Planning Commission Meeting Packet

December 12, 2017

Re: Parkway Village South – SP 17-01 / SUB 17-03,
Revised Staff Report

Parkway Village South Site Plan and Subdivision
SP 17-01 / SUB 17-03

Figure 11
Motor Vehicle Projects

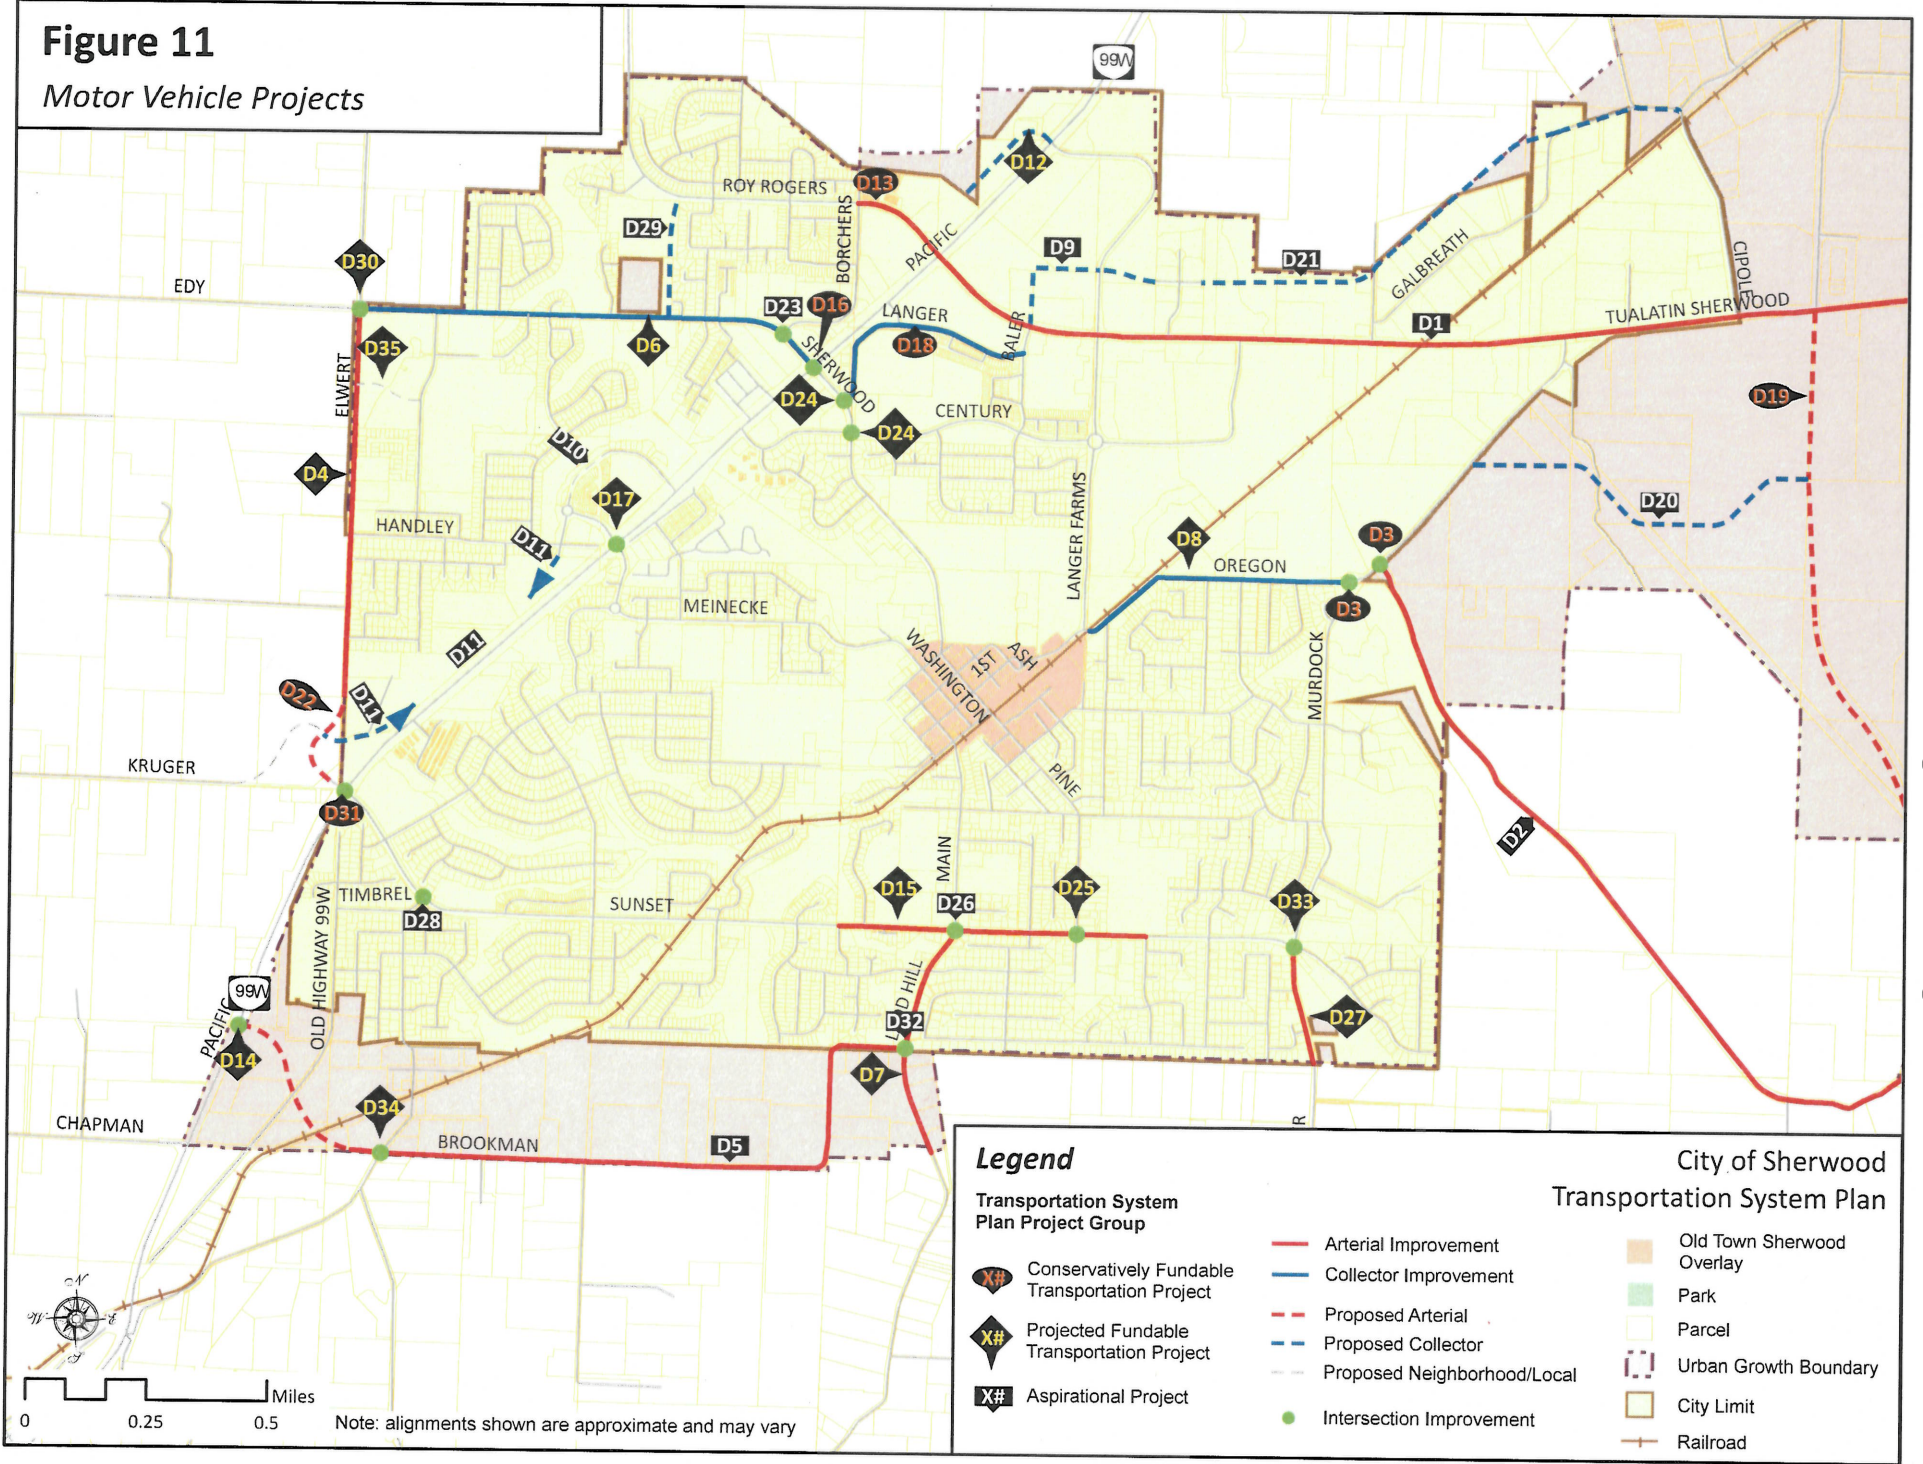
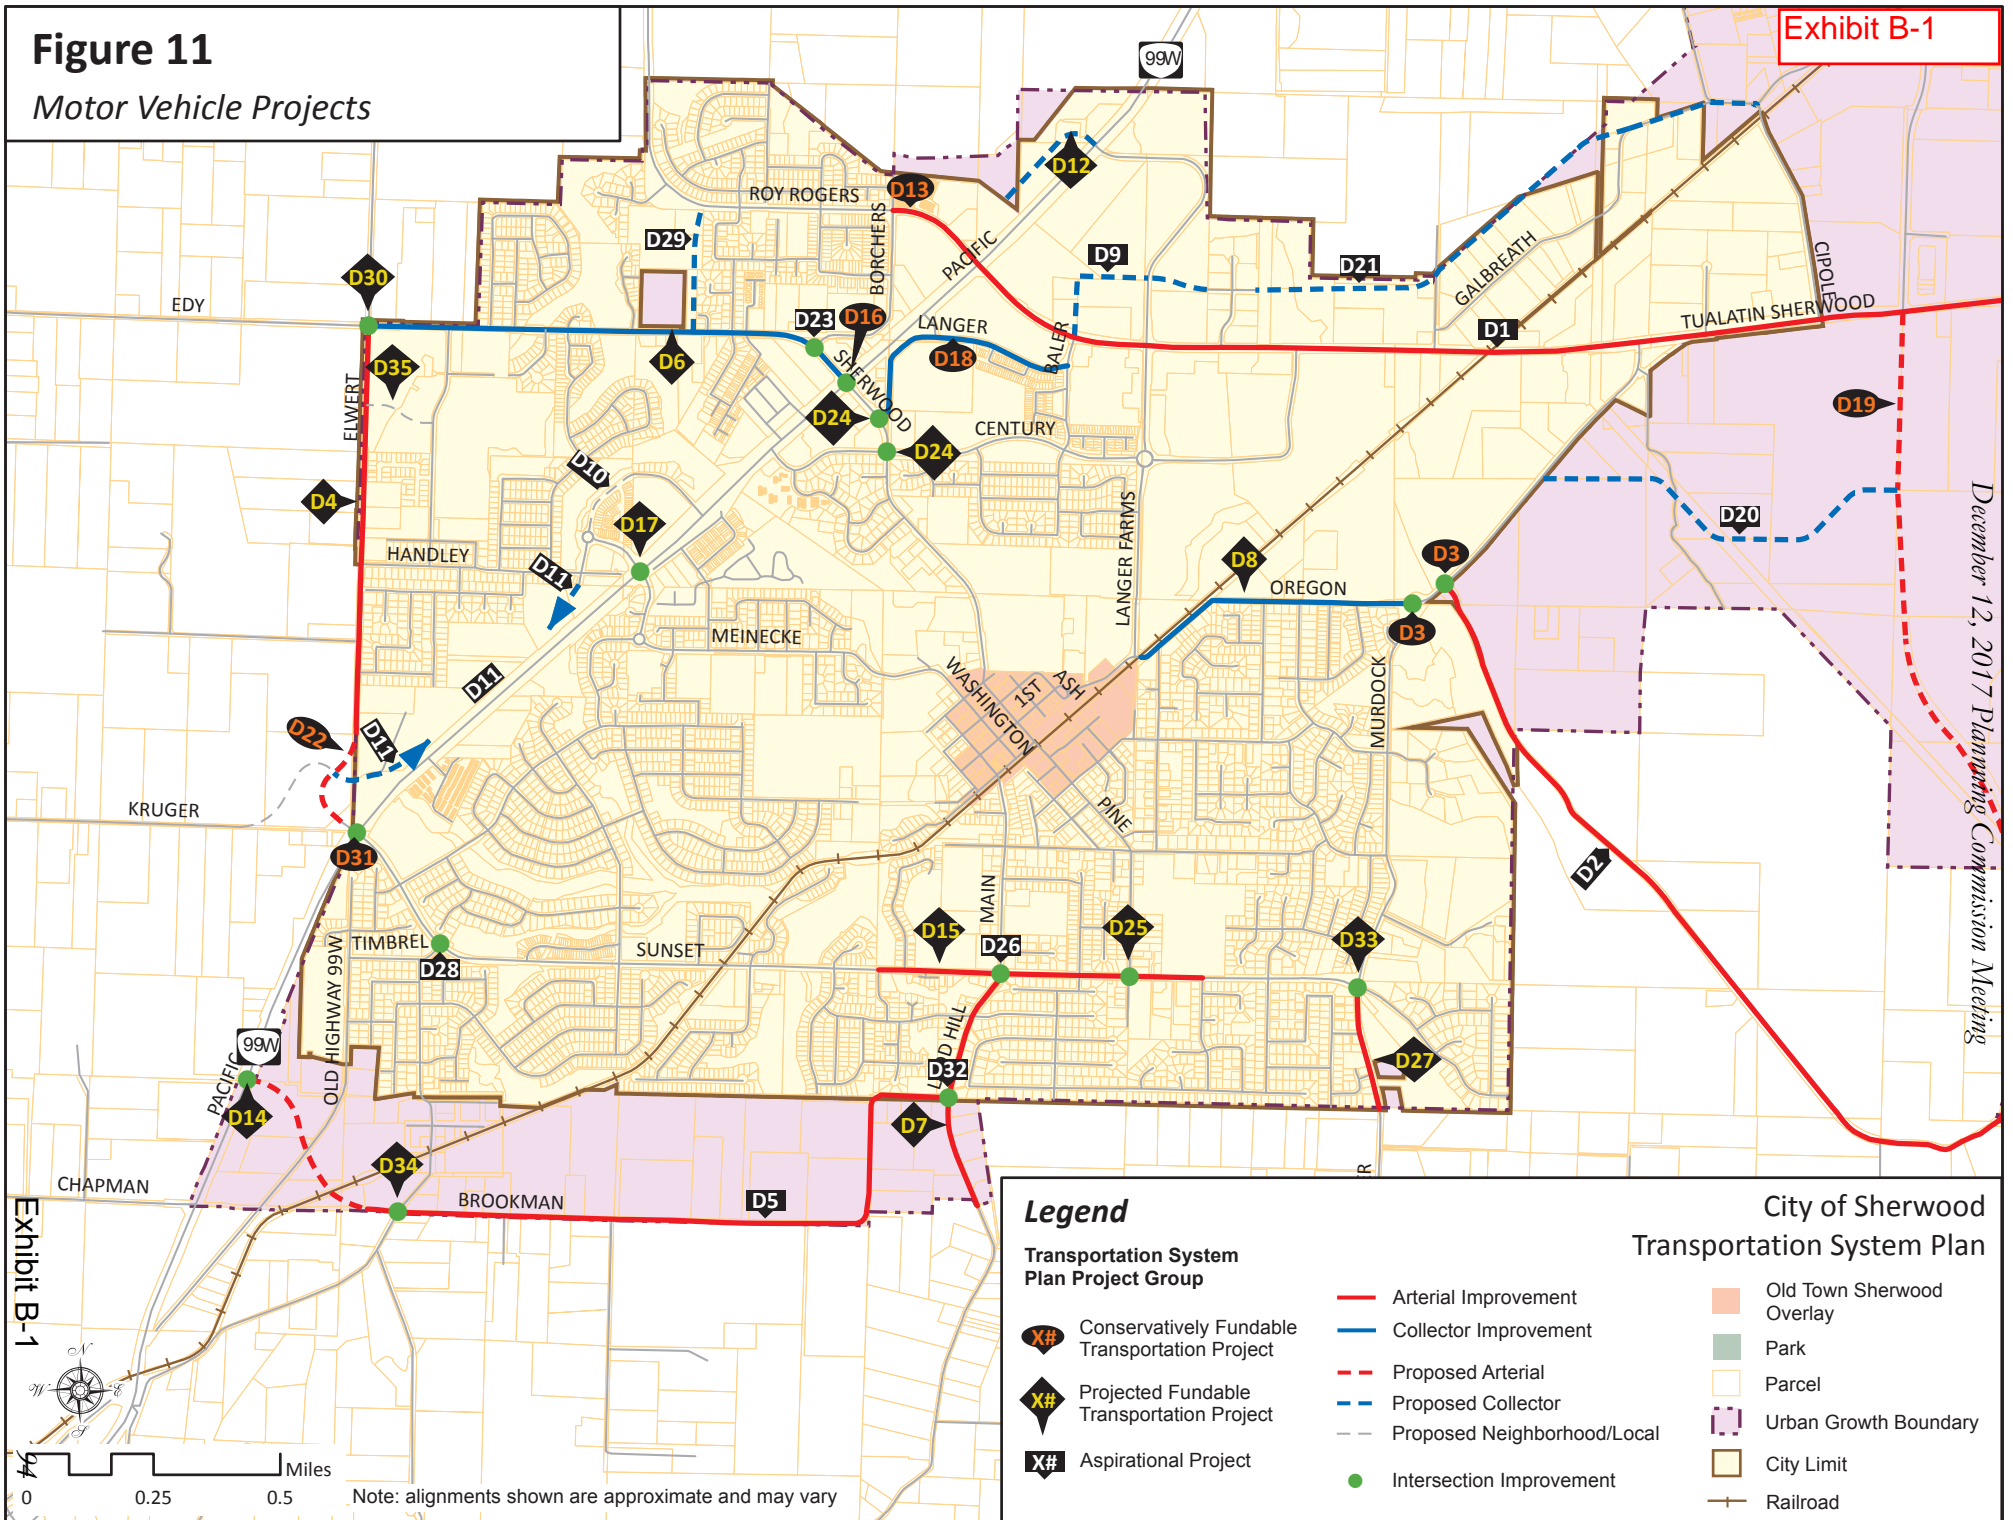
1. Section 7: "The Plan", Figure 11: This figure is modified to show Brookman as an arterial the entire length, not simply the realigned portion. See Exhibit B-1
 - *Note: This is a housekeeping edit because the Arterial Classification is consistent with the Functional Classification map on Figure 17 and is consistent with the project description for road projects in D5 in Section E of Volume 2. This edit also will make Figure 11 consistent with Washington County's Transportation System Plan.*
2. Section 8: "The Standards", Add Figure 17.b "Streets Where Right of Way Is Planned for More Than 2 Lanes." See Exhibit B-2
 - *Note: This map was in the previous TSP prior to the 2014 update. This map is a visual representation of Figures 16A to 16C (in the 2014 TSP) showing streets where right of way is planned for more than two lanes in Sherwood.*

This office represents The Holt Group, Inc. ("Holt"). Holt has reviewed the proposed amendment to the Sherwood Transportation System Plan (the "TSP") modifying TSP Figure 11 (**Exhibit 1**) to show Brookman Road as an Arterial street for its entire length, not just the realigned portion. As the summary of the amendments to the TSP notes, this amendment is a housekeeping amendment because the Arterial Street classification is consistent with the Functional Classification map on TSP Figure 17. Further, this amendment implements the settlement agreement entered into between the City of Sherwood and Washington County that resolved the appeal by Washington County to the Oregon Land Use Board of Appeals ("LUBA") of the City's annexation of property bordering Brookman Road.

Figure 1
Motor Vehicle Projects

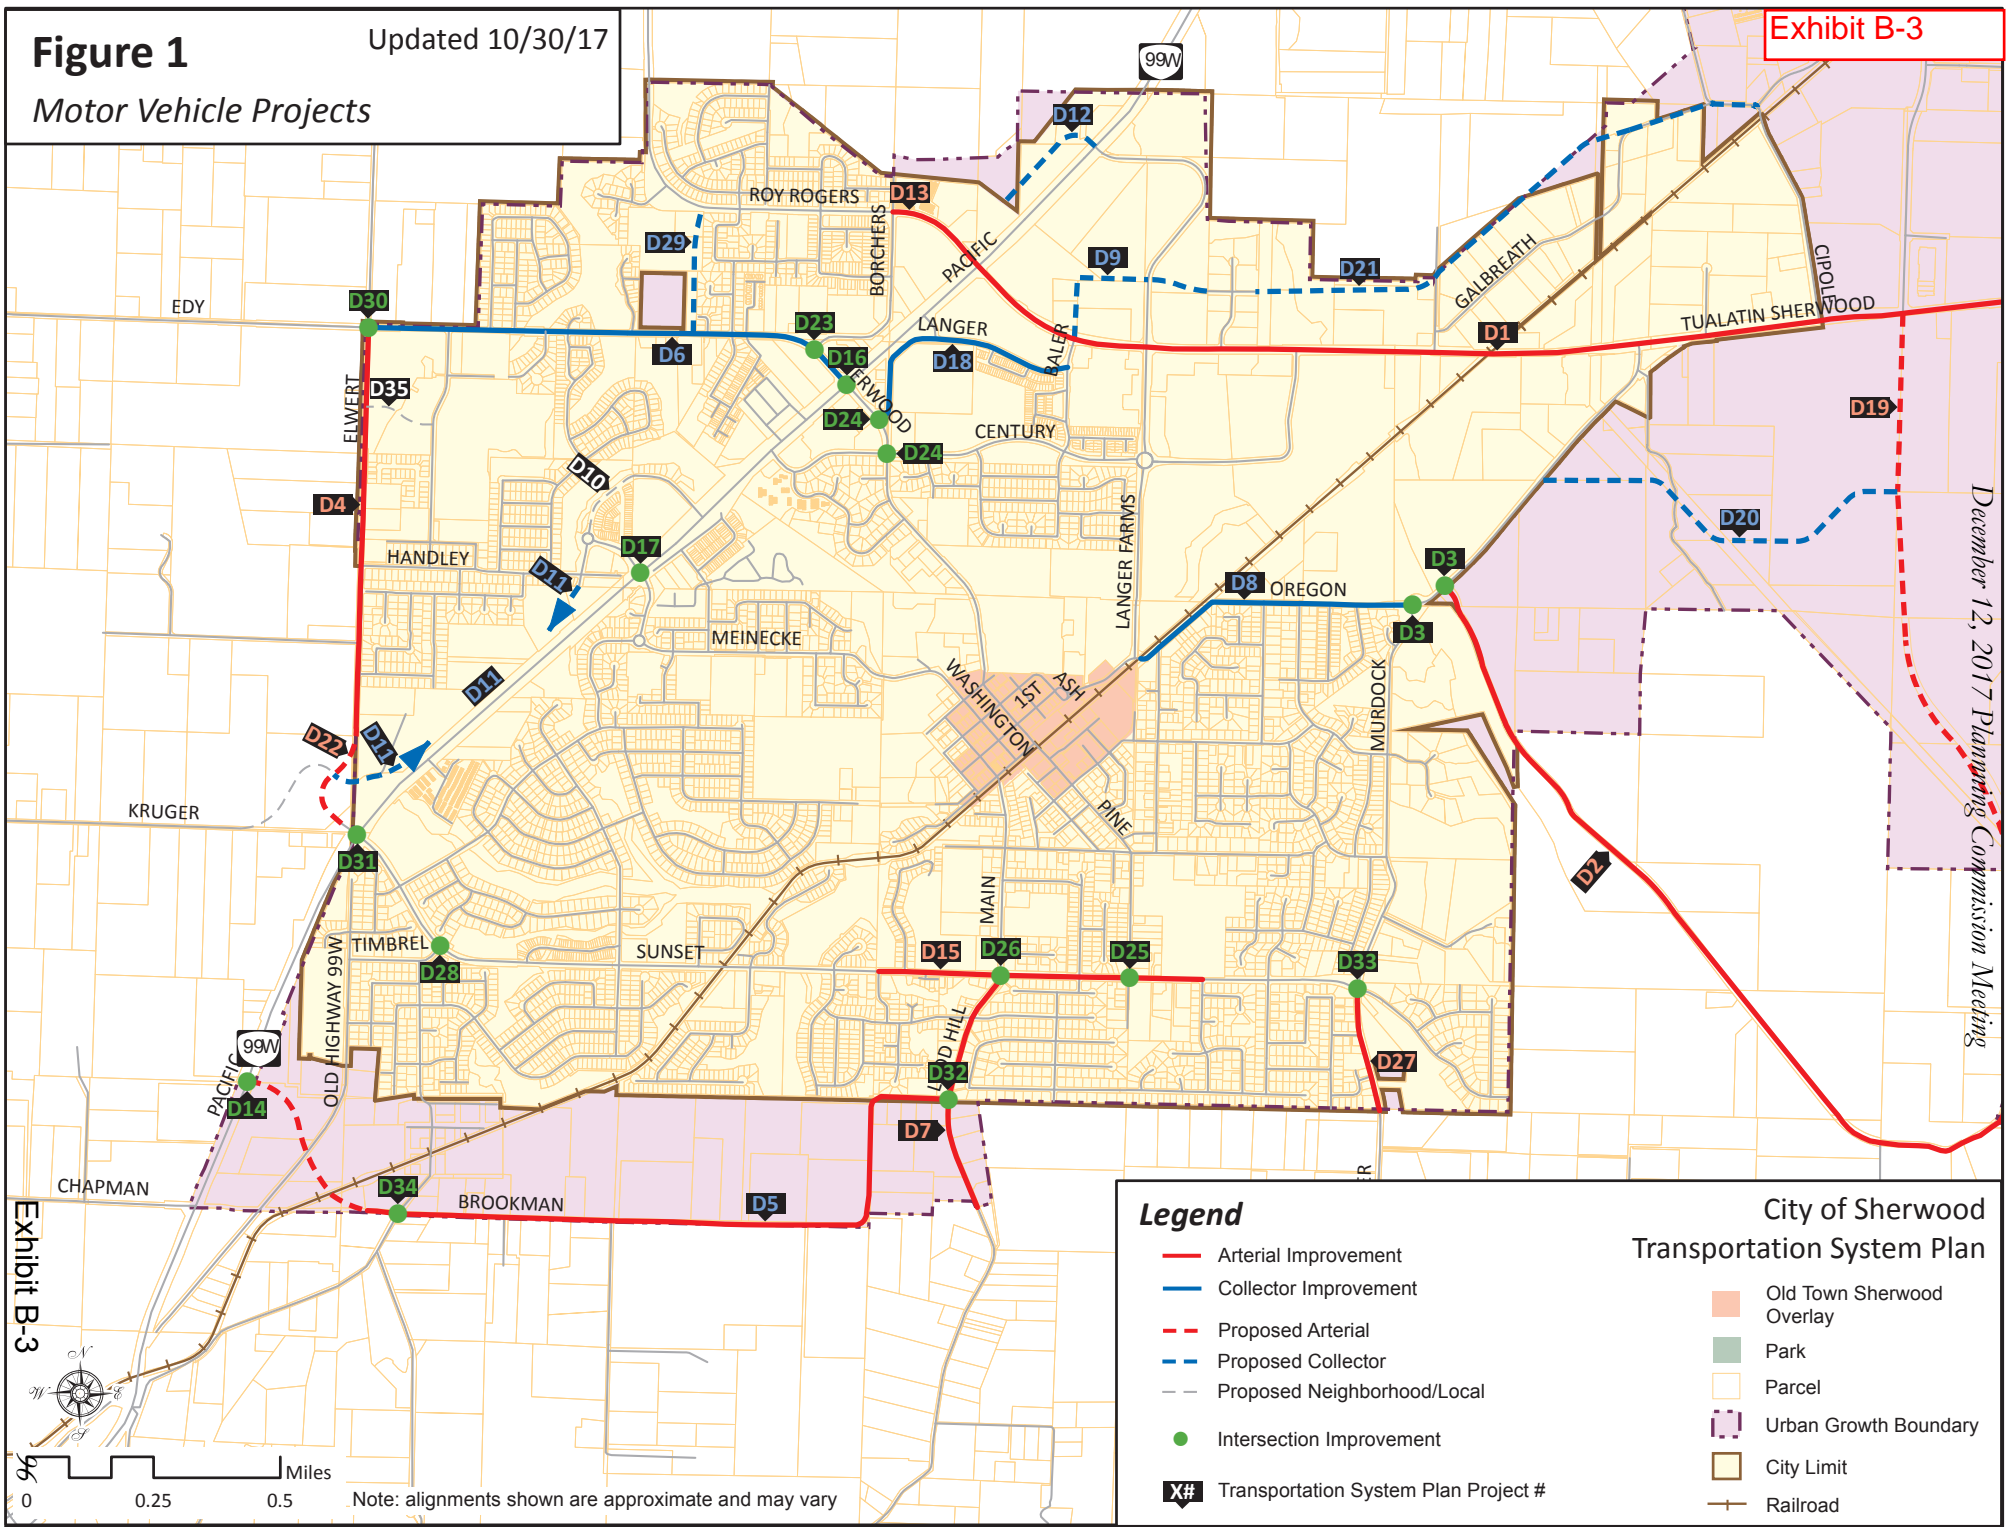
3. Section D: "Project Options Technical Report", Figure 1: Motor Vehicles Projects: This figure is updated to reflect Brookman as an arterial. See Exhibit B-3
